Housing Element Update

Final Environmental Impact Report
Responses to Comments on the Draft EIR

SCH#2022060323

June 2023

Figure 4.1-5a GUE-2 Looking North from Laughlin Road

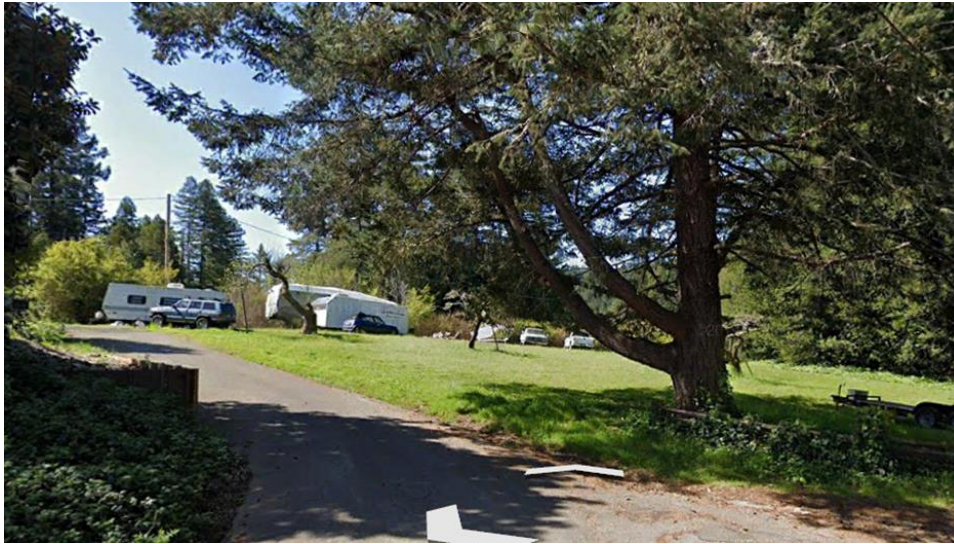
The commenter states Figure 4.1-5 of the DEIR is misleading since additional photos should show the immense valley view beauty which determines the visual character of Guerneville.

The commenter expresses the opinion that Figure 4.1-5 of the DEIR undermines the actual assessment of dominance in the area, and that the DEIR is missing a more in-depth and local view of the area.

It is unclear which property the commenter is referring to; however, we presume that the commenter resides on Site GUE-2. Figure 4.1-5 on page 4.1-12 of the Draft EIR, and the preceding text describing Figure 4.1-5 on page 4.1-11 of the Draft EIR, have been revised as follows:

The commenter's opinion is noted; however, Figure 4.1-5 is intended to provide views of GUE-2 and GUE-3 that is experienced by travelers on Cutten Road, and not views experienced by residents or visitors on GUE-2 or GUE-3.

The images provided in the Draft EIR are not exhaustive of the analysis conducted in the Draft EIR. Additionally, Figure 4.1-5 does provide a perspective of a clearly visible redwood tree. Redwood trees are prevalent in the area, and not located exclusively on GUE-3. Therefore, as described in Response 263.22, the EIR correctly characterizes GUE-3 as being co-dominant.

Page 2-17, Figure 2-9:

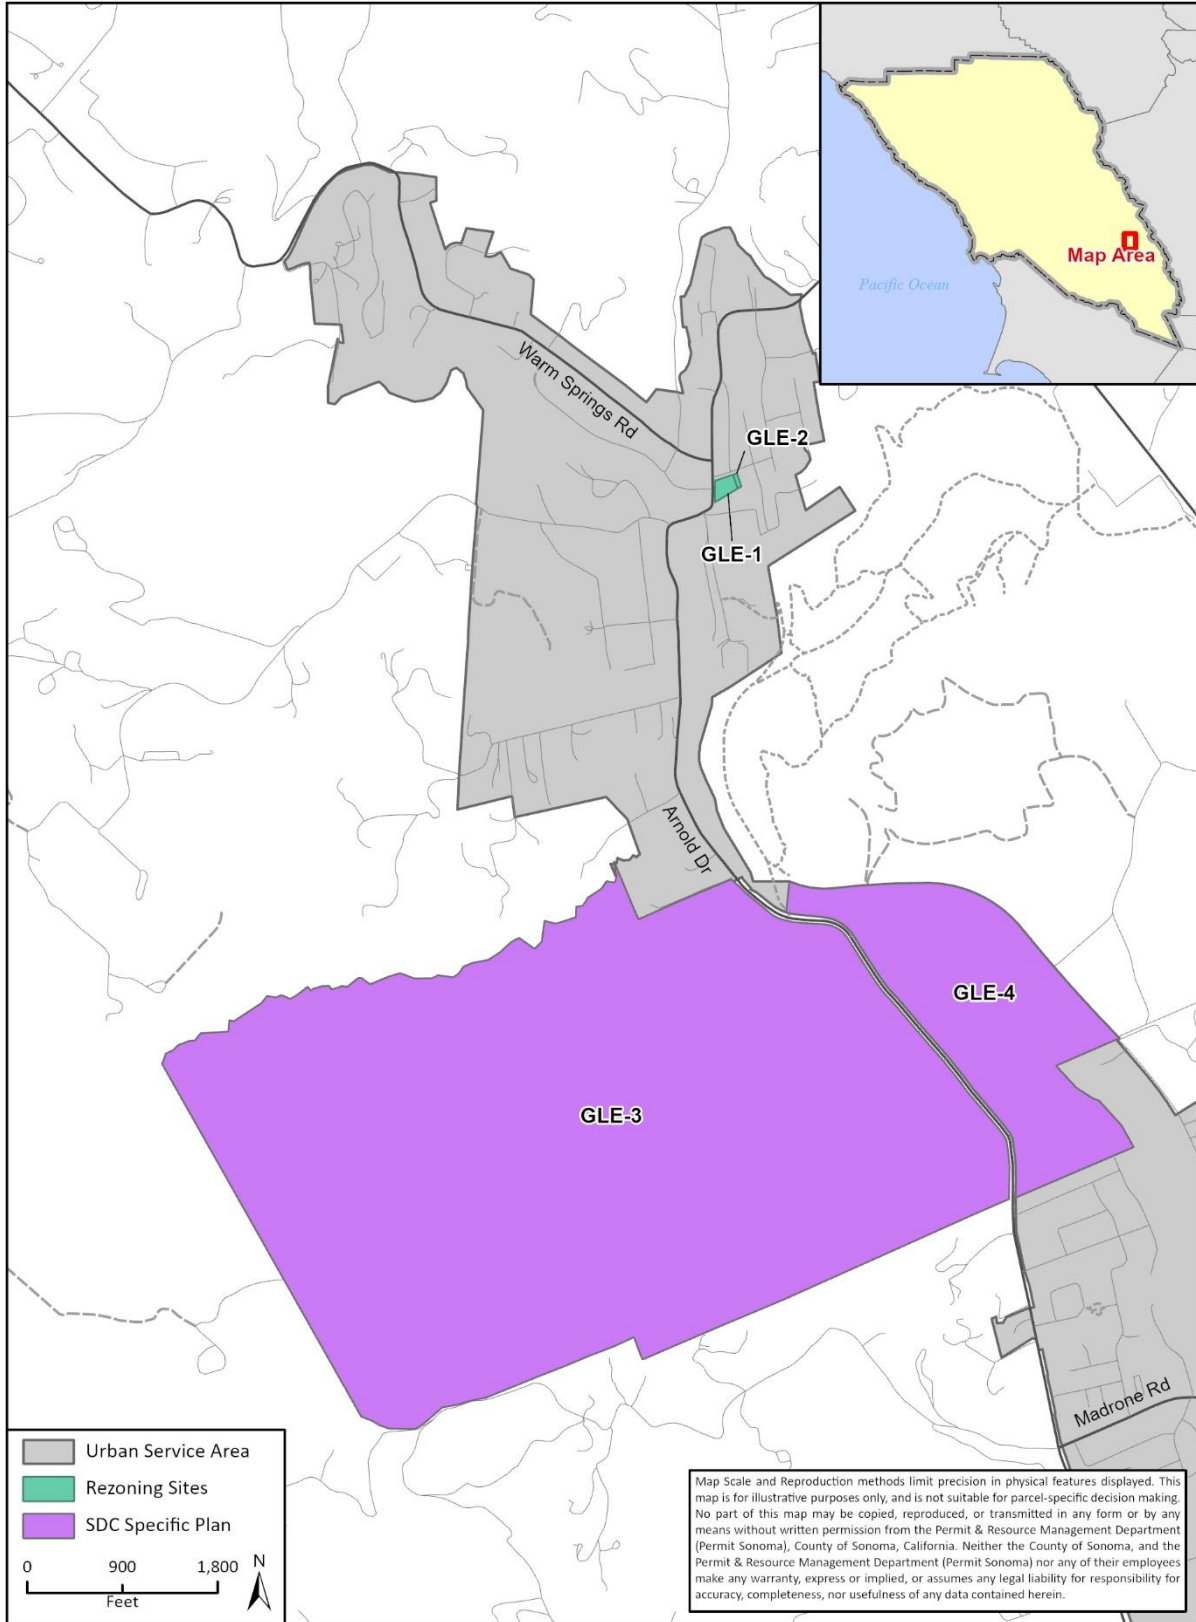
As shown in Figure 2-9 on page 2-17 of the Draft EIR, Sites GLE-1 and GLE-2 are within a designated Urban Service Area. Additionally, page 2-6 the Draft EIR has been revised for clarity, as there was a typographical error:
